SUBJECT: WATERFORD STEAM ELECTRIC STATION, UNIT NO. 3 - CORRECTION TO
AMENDMENT NO. 147 TO FACILITY OPERATING LICENSE NPF-38 (TAC
NO. MA3382)

SUBJECT: WATERFORD STEAM ELECTRIC STATION, UNIT NO. 3 - CORRECTION TO
AMENDMENT NO. 147 TO FACILITY OPERATING LICENSE NPF-38 (TAC
NO. MA3382)

FIGURE 3.1-1

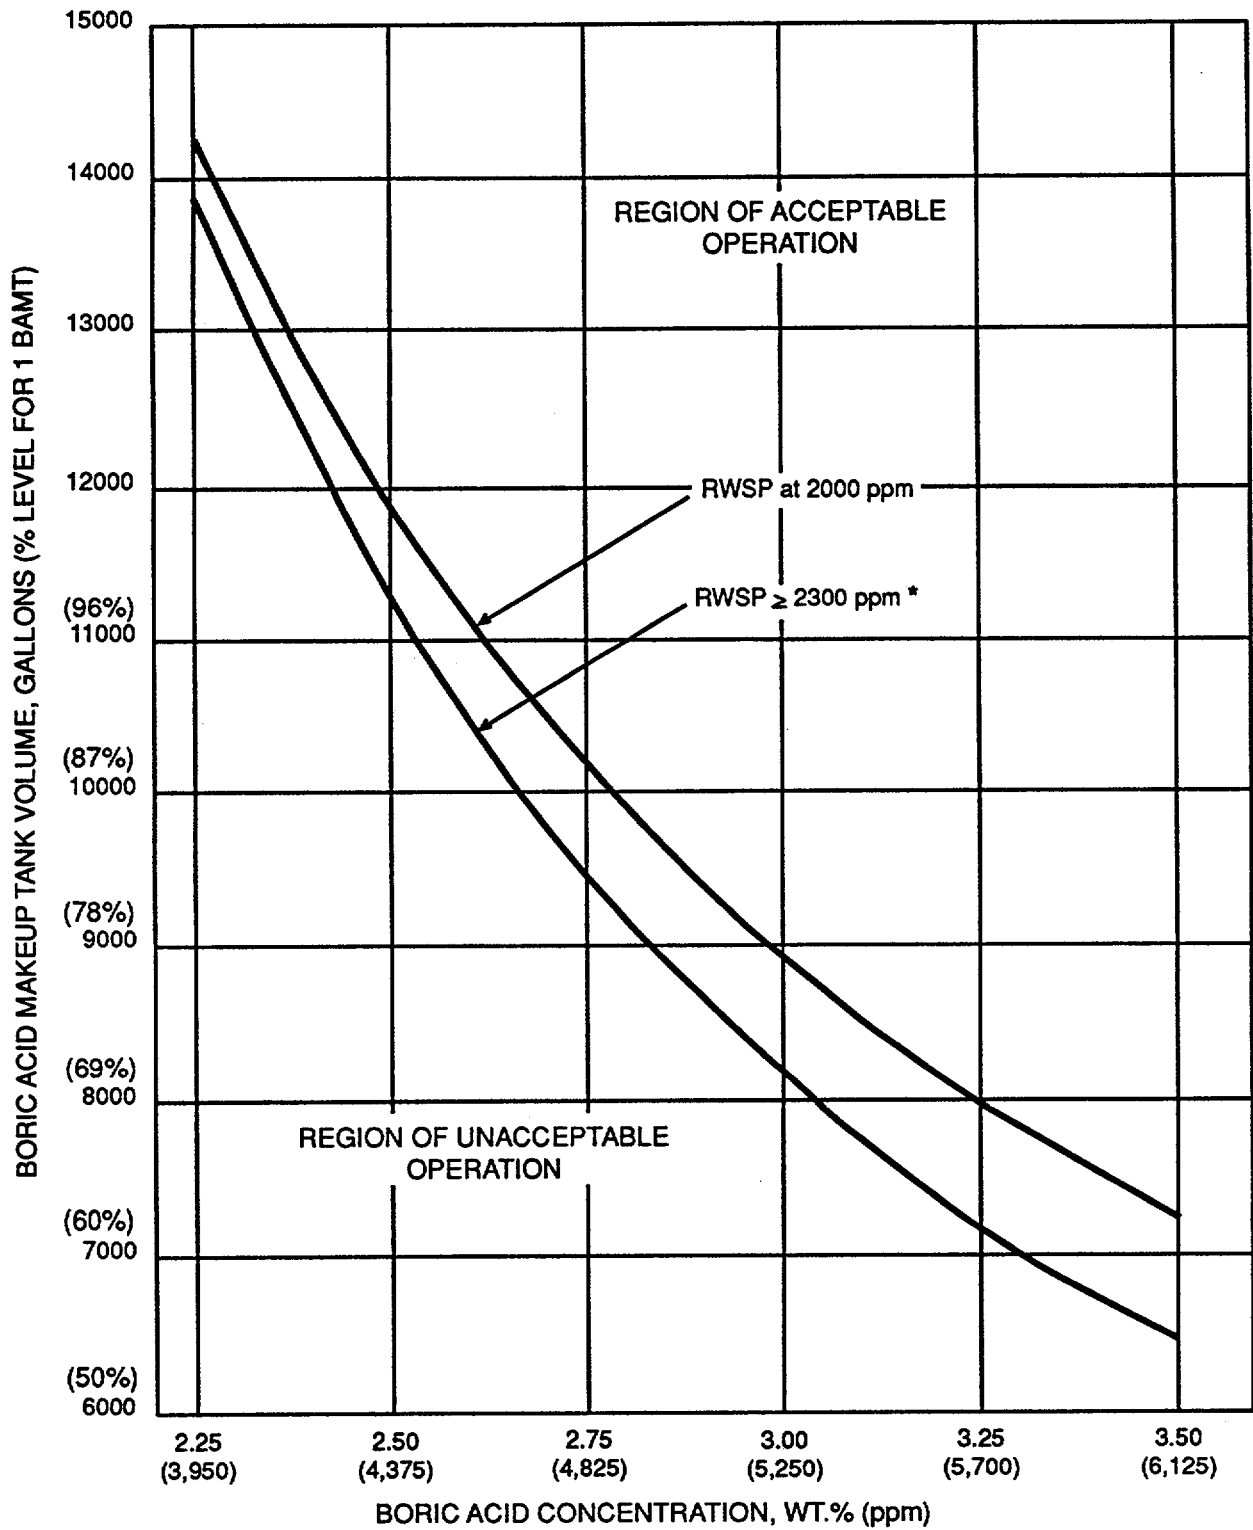
Amendment No. 147 was issued with a typographical error in Figure 3.1-1. The word "ACCEPTABLE" should be "UNACCEPTABLE" in the lower portion of the figure. This error was introduced during processing of the Amendment. The corrected figure is enclosed.
